Access Compliance Report

Public Rights-of-Way

(Curb Ramps)

Intersection ID: 23717	Main Street: E WESTINGHOUSE BV	Cross Street: CHINA GROVE CHURCH RD	Location: NE
ADA ID: E8FB4B51A1E8	Ramp Type: PerpDiag	Initial Pass/Fail: Fail	Overall Compliance: No
Codes/Mitigation Info/Possible Solution		Field Measurements/Component Compliance	
Severity Score: 12.5

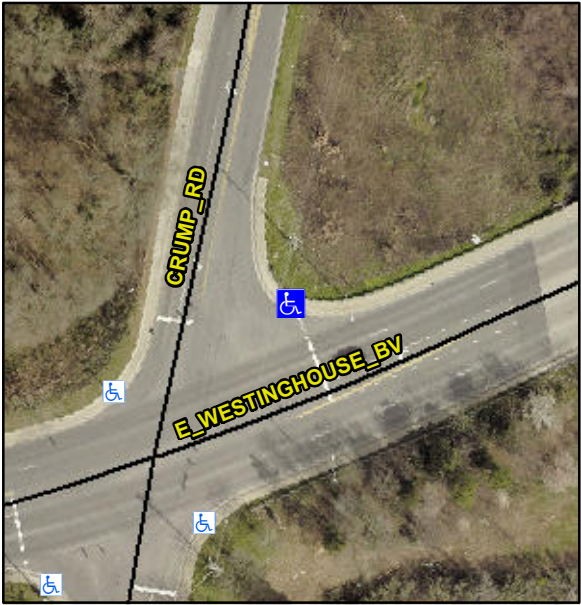
Possible Solutions:		Compliance	Description	Data	Compliance	Description	Data
	Remove & Replace Curb Ramp With Two New Directional Ramps or Equivalent.		N/A	Ramp Length (in)	61.0	No	Ramp Slope (%)	10.8
<p>Surveyor Notes:</p> <p>N/A</p> <p>PROW/ADA:</p> <p>Not Found, R304.2.2</p>			Yes	Ramp Width (in)	51.0	Yes	Ramp XSlope (%)	0.9
			N/A	Flare Type LT	N/A	N/A	Flare Type RT	N/A
<p>Street 1 Name</p> <p>CRUMP RD</p> <p>Stop Condition-Street 2</p> <p>Signal</p> <p>Street 2 Name</p> <p>E WESTINGHOUSE BV</p> <p>Stop Condition-Street 1</p> <p>Signal</p>			N/A	Flare Slope LT (%)	N/A	N/A	Flare Slope RT (%)	N/A
			N/A	Flare Traversable LT?	N/A	N/A	Flare Traversable RT?	N/A
<p>Total Cost:</p> <p>\$ 3200.00</p>			N/A	Landing Length (in)	N/A	N/A	DWS Provided?	N/A
			N/A	Landing Width (in)	N/A	N/A	DWS Contrast?	N/A
			N/A	Landing Slope (%)	N/A	N/A	DWS Length (in)	N/A
			N/A	Landing X Slope (%)	N/A	N/A	DWS Full Width?	N/A
